**ADDENDUM NO. 11**

**DELAWARE STATE UNIVERSITY (OWNER)  
OPTICAL SCIENCE CENTER FOR APPLIED RESEARCH  
Contract Nos.:  
PC-2014-006B-OSCARIT (I.T. Cabling)  
1220 N. DuPont Highway  
Dover, DE 19901**

**THE WHITING-TURNER CONTRACTING COMPANY  
(CONSTRUCTION MANAGER)  
1200 N. DuPont Highway  
Dover, DE 19901  
302-857-6883 (phone)**

**NOTICE TO ALL BIDDERS**

**e4.5** riser diagrams  
telecomm

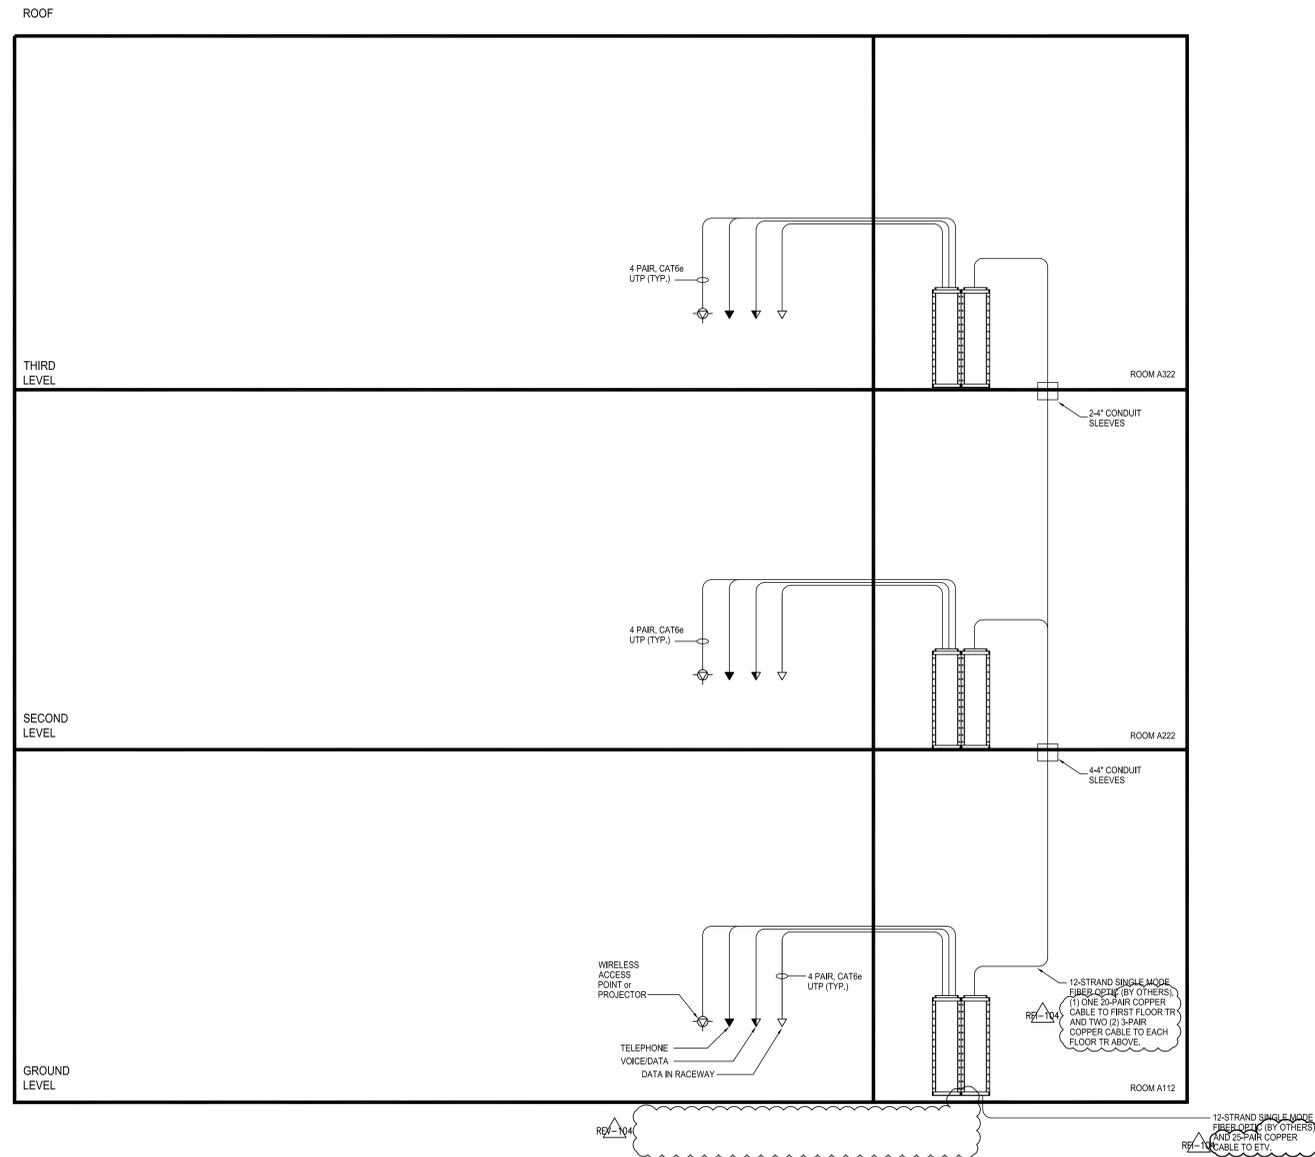
3.1 E4.5 Riser Diagrams Telecom **(REVISED)**

4. Conduit, raceways, cable trays and ladder trays are being installed by the 16A Electrical contractor except those shown on e4.5. All sleeves, conduit, raceways and all fire stopping required for work shown on e4.5 shall be by this Contractor.

e5.2 details

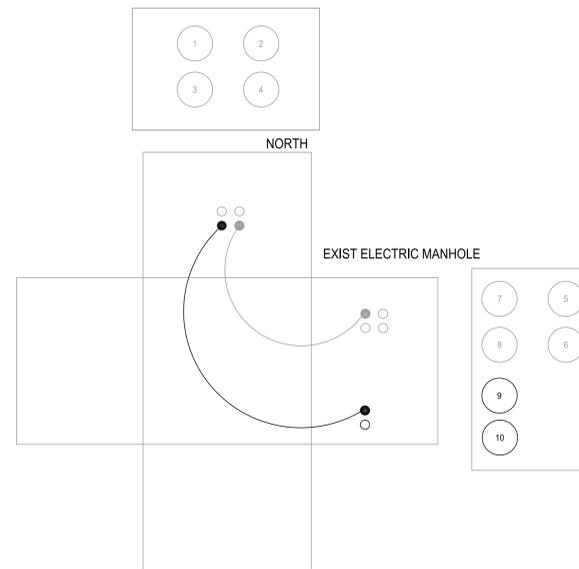
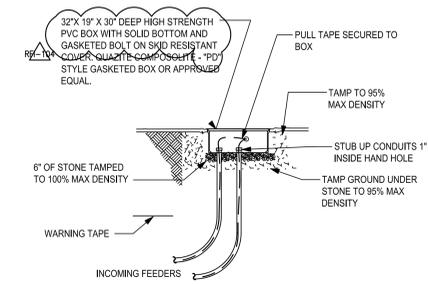
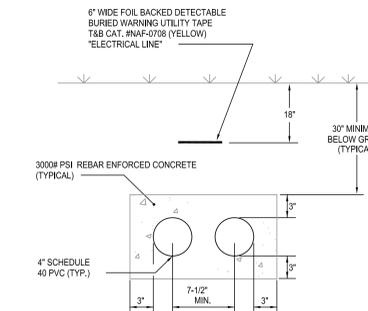
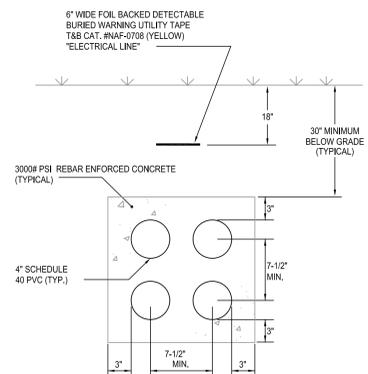
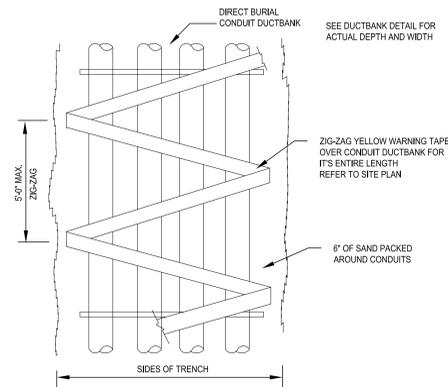
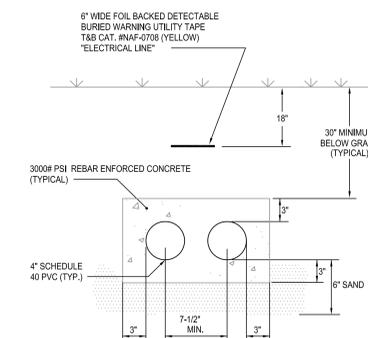
3.2 E5.2 Details **(REVISED)**

**es1.1 site plan new**

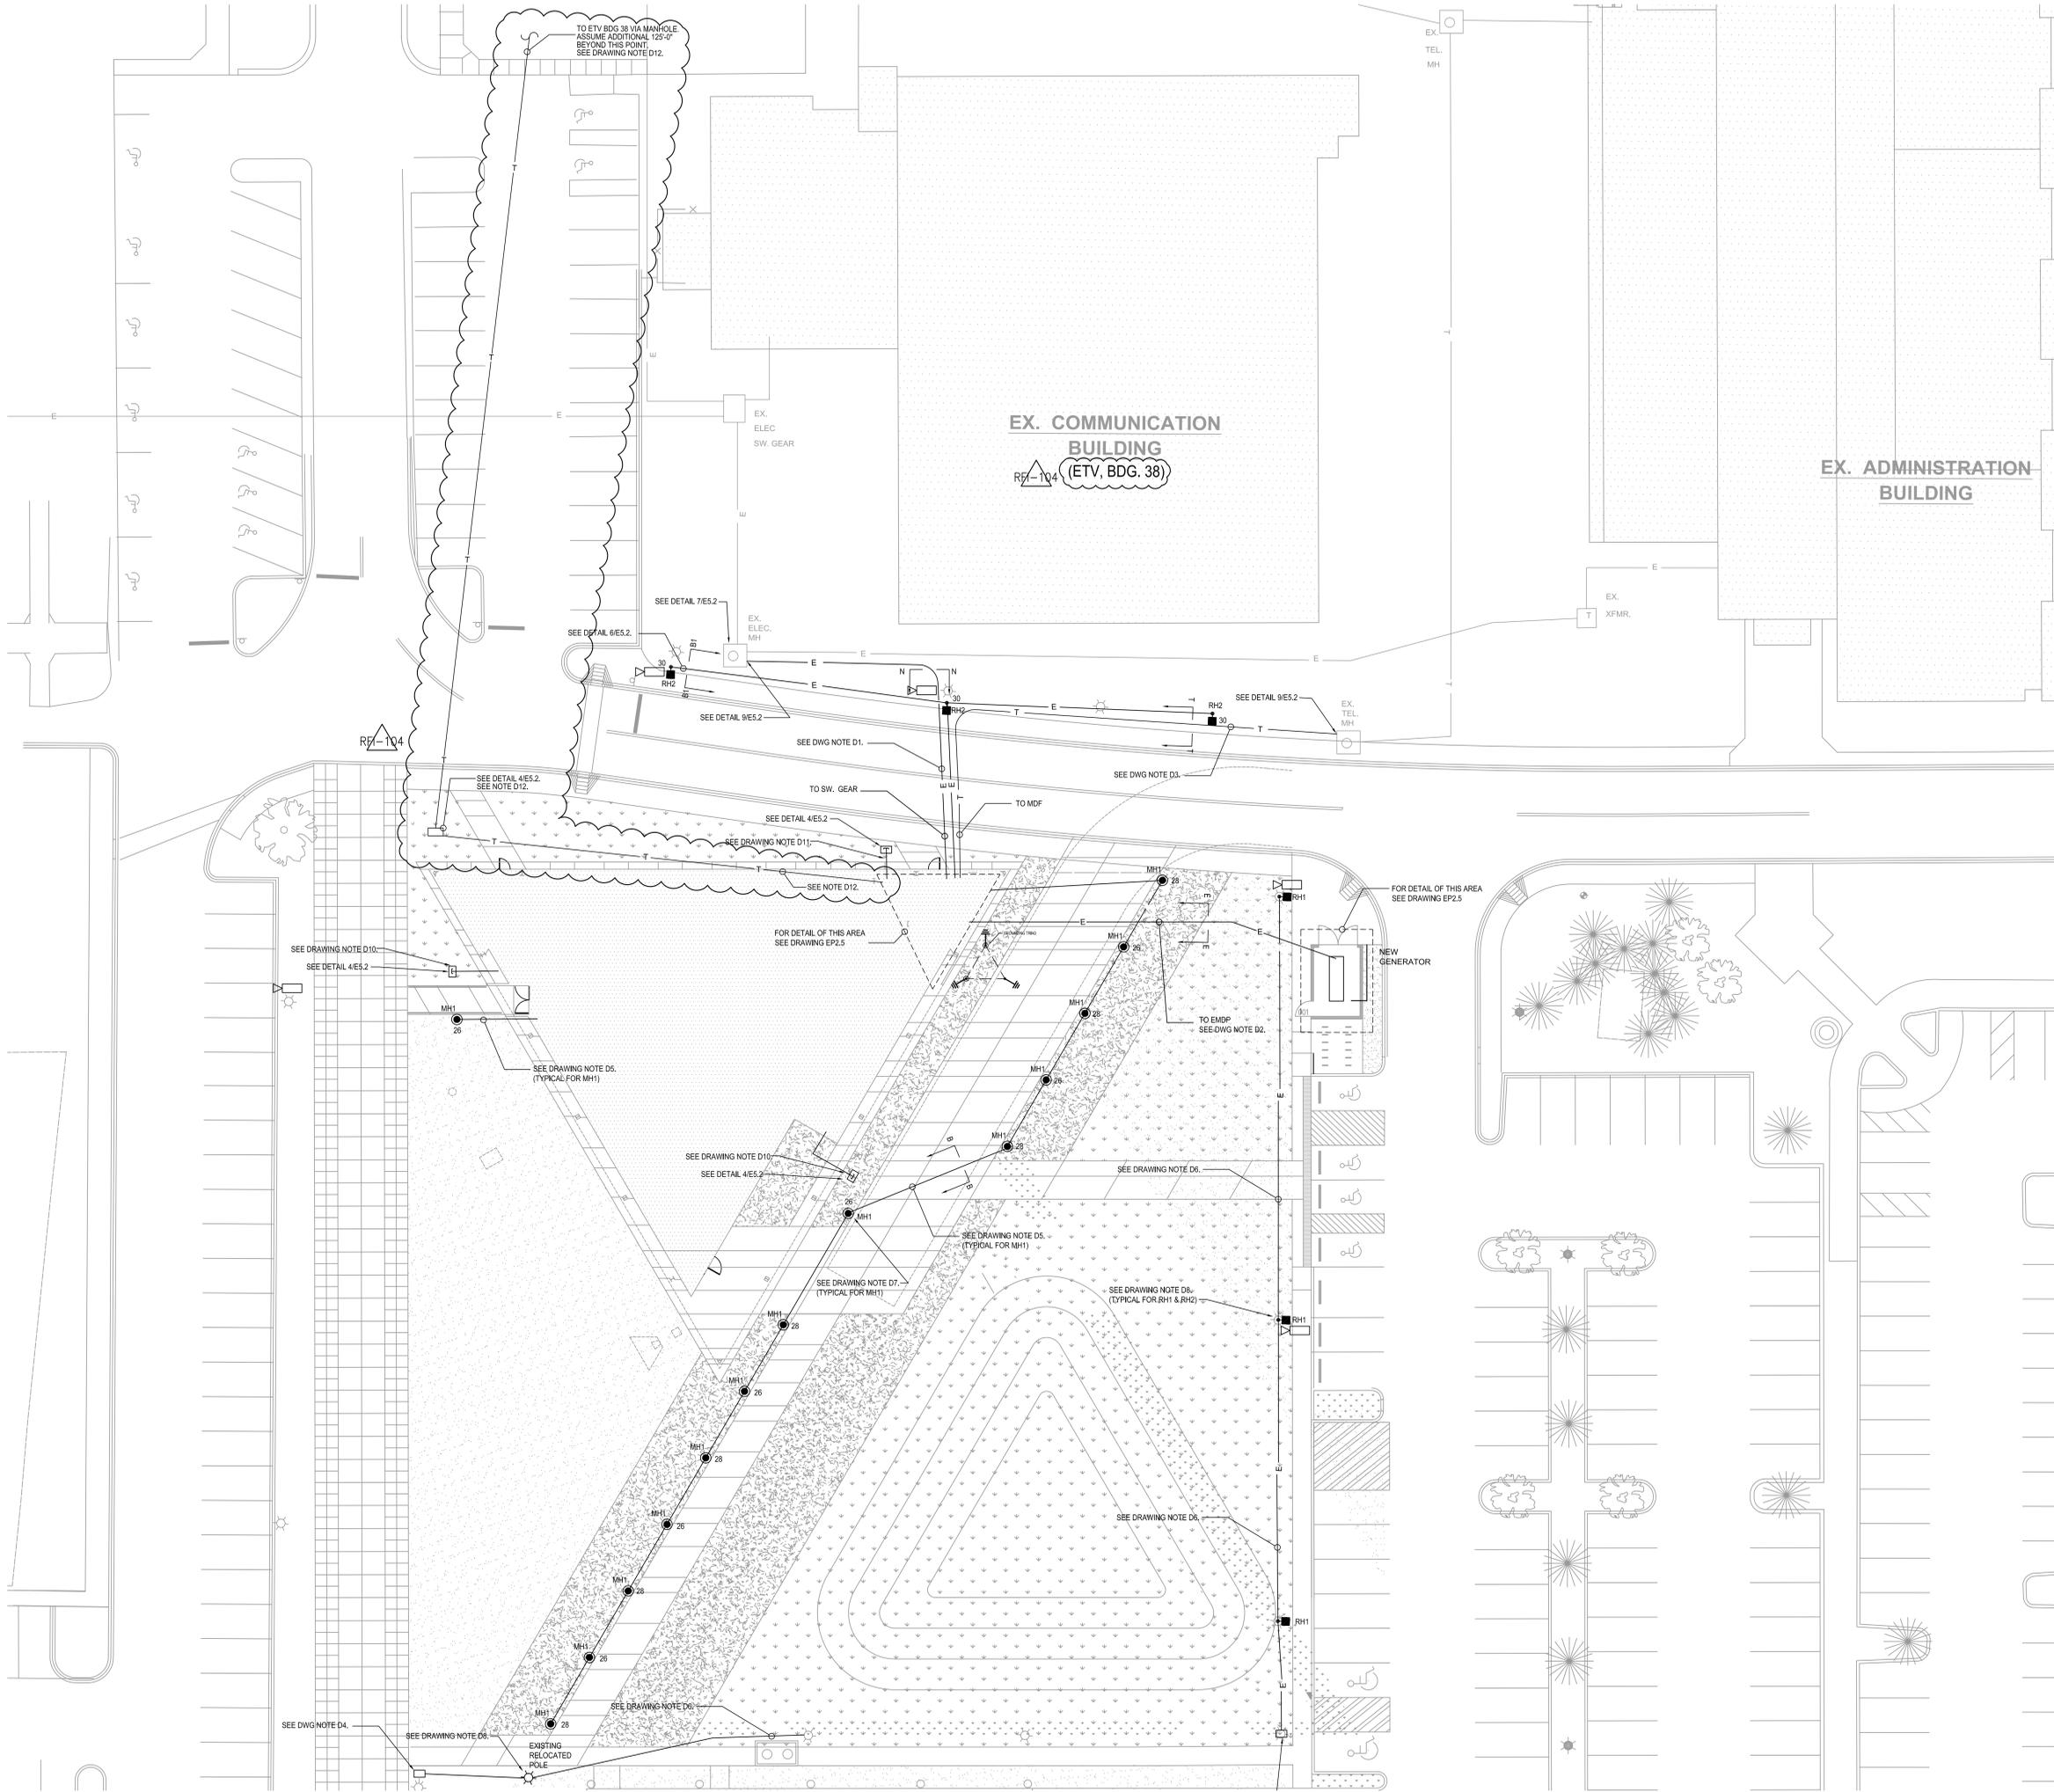
- 1.6 The due date for **Bid Package 16B – I.T. Cabling** is **Friday June 27, 2014 at 10 AM**.
- 1.7 The fiber optic wiring shall be brought into the building as part of a separate contract with the Owner by others. As part of this bid package, this Contractor shall bring 25-pair copper cable to room A112 in the new OSCAR building from the existing IDF closet in the ETV building. The route for this is shown on the revised es1.1 drawing issued in this addendum.

3.3 ES1.1 Site Plan New **(REVISED)**

14. ~~Telecom~~ **New 25-pair copper wire** is to be fed from **ETV Building through new and existing raceways existing manhole** as shown on es1.1. It is suggested that bidders request a site visit to investigate the condition and contents of this manhole. It will be the responsibility of this Contractor to provide any coordination required with the Owner and will own any work required to tie into the existing campus systems. **The path of the new copper wiring shall originate in the existing IDF room in the ETV building and be routed through existing conduit to an existing manhole to the northwest of the ETV building. It will then be routed through new conduit/innerduct southward to a new junction well just north of the new OSCAR building. From that point it will continue through new conduit/innerduct to Room A112 in the new OSCAR building. The new raceway work and junction well described in this line item shall be by others. The fiber optic wiring shall be installed under a separate purchase order through the Owner by others from Grossley Hall into the new OSCAR building Room A112 and is NOT part of this bid package. Disregard section 1.04E of specification section 16740 as this work is by others.** **ADDENDUM 11**
